### Specific Design Plan Case Yergat

REQUEST	STAFF RECOMMENDATION
Grading infrastructure only for a residential community.	With the conditions recommended herein:
	<ul> <li>Approval of Specific Design Plan SDP-2203</li> <li>Approval of Type 2 Tree Conservation Plan TCP2-048-2022</li> </ul>

SUBJECT: Specific Design Plan SDP-2203

Type 2 Tree Conservation Plan TCP2-048-2022

Figure 2: Grading Infrastructure Plan

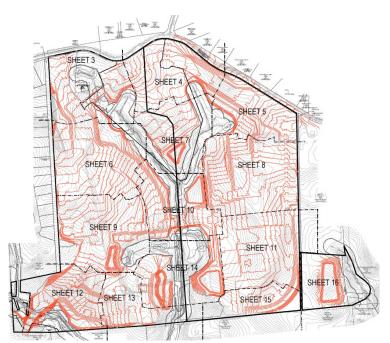
This SDP is for infrastructure only. Specifically, the application proposes grading, clearing, and sediment control/stormwater management (SWM) devices for the property. All areas shown to be impacted by this application will ultimately be developed with residential units, in conformance with the approved CDP and PPS 4-21049 applicable to the property. A Type 2 tree conservation plan (TCP2) has been submitted for review with this application.
